Technical Service Bulletin: TSB250112

Lubricating Oil Leaks from Turbocharger Compressor Outlet

- QST30 CM552

Figure 1, Example of Turbocharger Joint (LB shown).

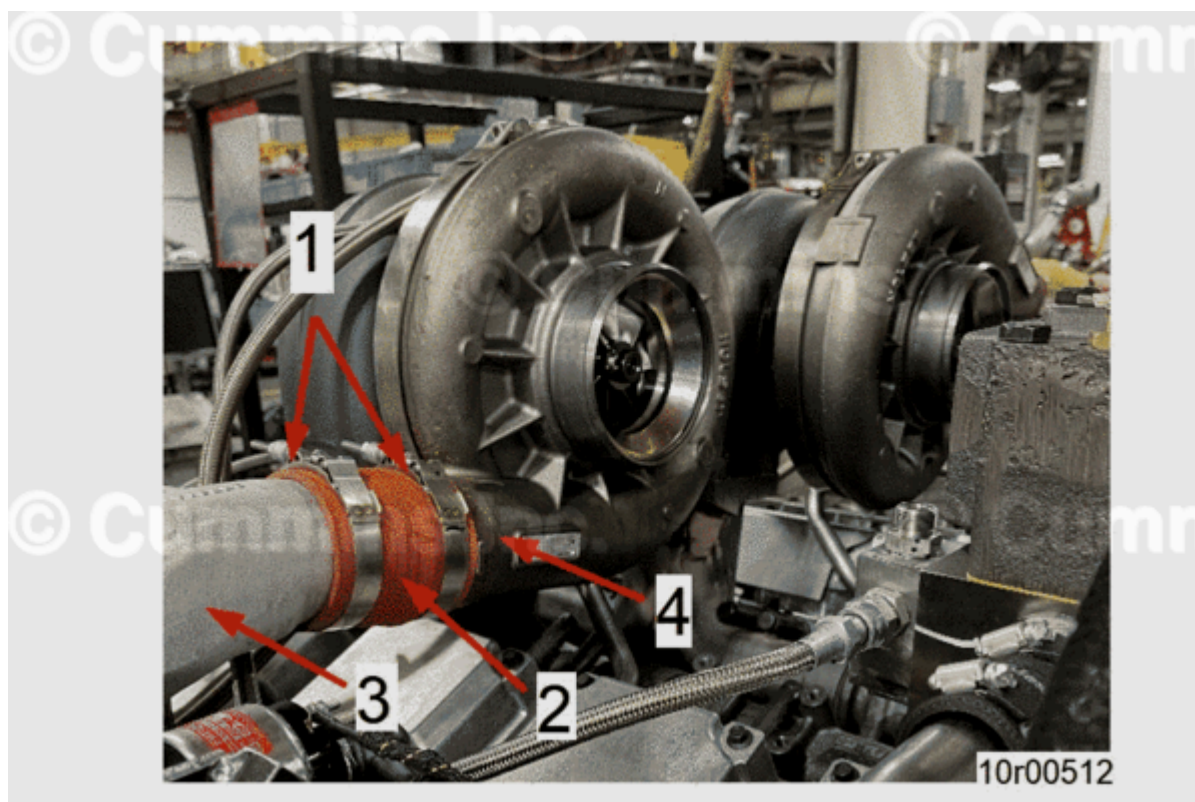
- With prolonged operation in low-load and low-speed conditions, lubricating oil can accumulate in the turbocharger bearing housing and leak past the turbocharger compressor seal, leaking externally at the air crossover hose connection between the turbocharger compressor outlet and air crossover inlet.

Fast-setting RTV is to be applied to the hose connections at the turbocharger compressor outlet and air crossover inlet. Reference Service Instruction section.

- Loosen the T bolt clamps (1) on the air crossover hose (2).
- Refer to Procedure 010-019 (</qs3/pubsys2/xml/en/procedures/57/57-010-019-tr.html>) in Section 10 to remove the air crossover.

- Remove the T bolt clamps (1) from the air crossover hose (2) and remove the hose from the turbocharger compressor outlet (4).
- Clean the outer surfaces of the air crossover inlet (3) and turbocharger compressor outlet (4).
- Clean the inner surface of the air crossover hose (2).
- Apply a bead of Loctite RTV Gasket Maker: SI 587, Part Number 135504, or equivalent, to the outer surface of the air crossover inlet (3) and the turbocharger compressor outlet (4) behind the lip of the inlet/outlet.
- Install the air crossover hose (2) onto the turbocharger compressor outlet (4).
- Loosely install the T bolt clamps (1) onto the hose (2).
- Refer to Procedure 010-019 (/qs3/pubsys2/xml/en/procedures/57/57-010-019-tr.html) in Section 10 to install the air crossover (3).
